RE: **Recall Campaign Launch Notification**
Replace Rear Door Latches
MY19-21 463(G-Class)

Campaign No. 2021060014, July 2021
Revision A July 2021

SUBJECT: **Model G-Class vehicles (463 platform)**
Model year 2019-2020

Replace Rear Door Lock – Code XZ8/XZ9 (MY19/MY20)

Figure 3

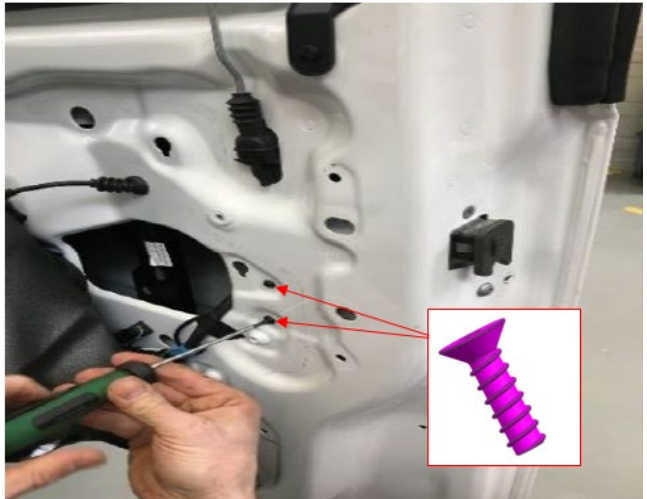
i The mounting screws on **CL actuators (Figure 3) MUST be replaced** and are included with the parts kit.
